8XC251Sx (8XC251SA, SB, SP, SQ) SPECIFICATION UPDATE

Release Date: September, 1998

Order Number: 272836-006

Figure 1. External Code Fetch, Nonpage Mode

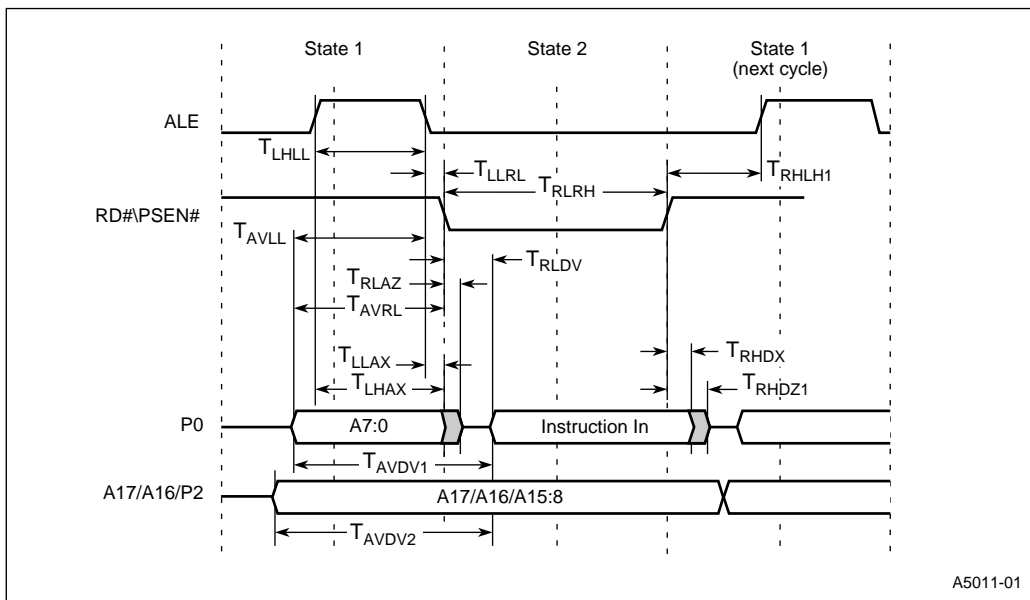
PROBLEM: The TRHDZ1 (Instruction Float After RD#/PSEN# High) specification on the 8XC251Sx when operating at 12 MHz is 10 ns. However, a slow memory device such as an EPROM typically takes approximately 30 – 90 ns to float its output. (This specification generically called TPHZ, may vary from one manufacturer to another.) and illustrate the TRHDZ1 timing.

The difference between the TRHDZ1 and TPHZ specifications causes contention on the data bus (P0 in nonpage page, P2 in page mode). The 8XC251Sx begins to drive the address for the next bus cycle while the memory device is still driving data from the previous bus cycle.

To prevent this contention, designers can use a buffer to isolate the output of the memory device from the data bus (port 0 or port 2) of the 8XC251Sx. This will prevent the slow memory device from driving the data bus during the critical period after TRHDZ1 expires. We suggest a buffer such as the 74F541 octal, three-state line driver shown in Figure 3.

Figure 3. Example Bus Contention Solution for 8XC251Sx

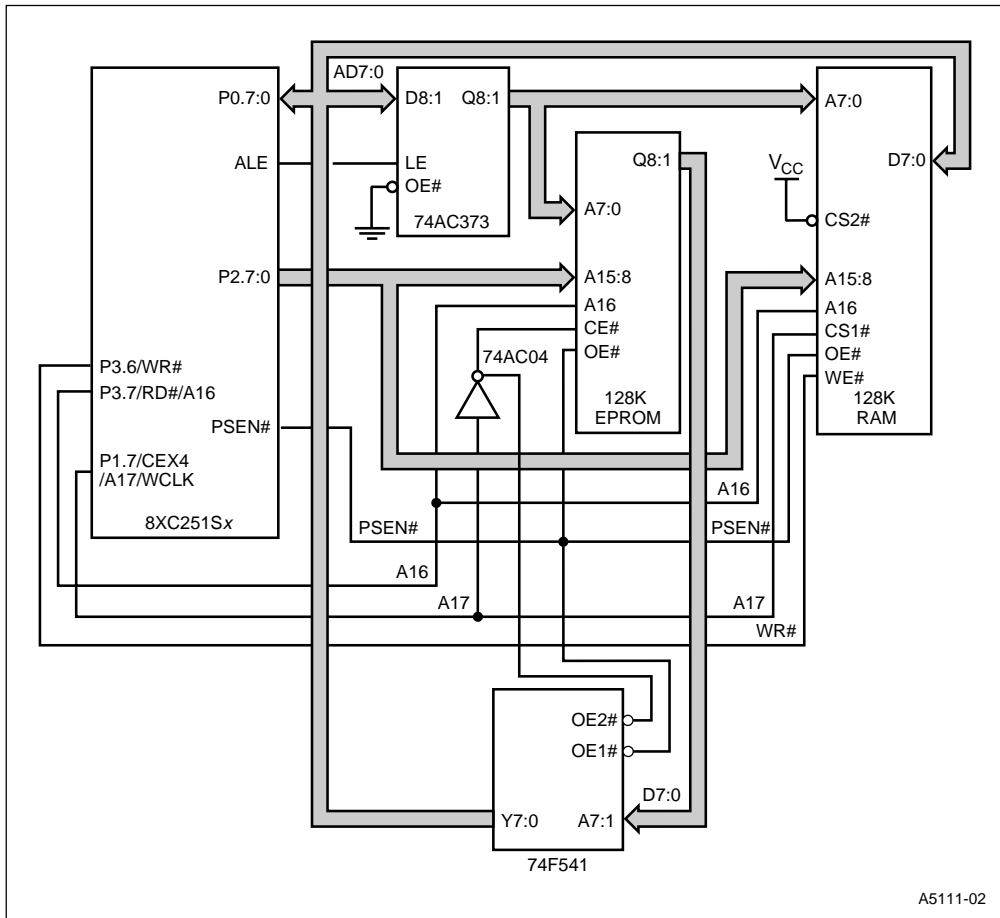
Figure 3 illustrates the connections of an 8XC251Sx configured for nonpage mode with EPROM and RAM in external memory. If your system uses a different configuration, your circuit will be different from the example. The 74F541 is enabled to pass data from the EPROM to the 8XC251Sx (port 0) when OE1# and OE2# are active. Table 1 is a truth table for the 74F541.

During a read, PSEN# turns the buffer on (OE1# and OE2# are active), connecting the EPROM's output to the 8XC251Sx's port 0.

When PSEN# goes high after a read, 1G# and 2G# are deasserted and the buffer's output switches to the high-impedance state in approximately 9.5 ns (TPHZ for a typical 74F541; the value may vary from one manufacturer to another). Thus, contention on the data bus is prevented. This or a similar hardware solution is recommended for 8XC251Sx designs in which slower memory devices do not meet the TRHDZ1 timing specification.
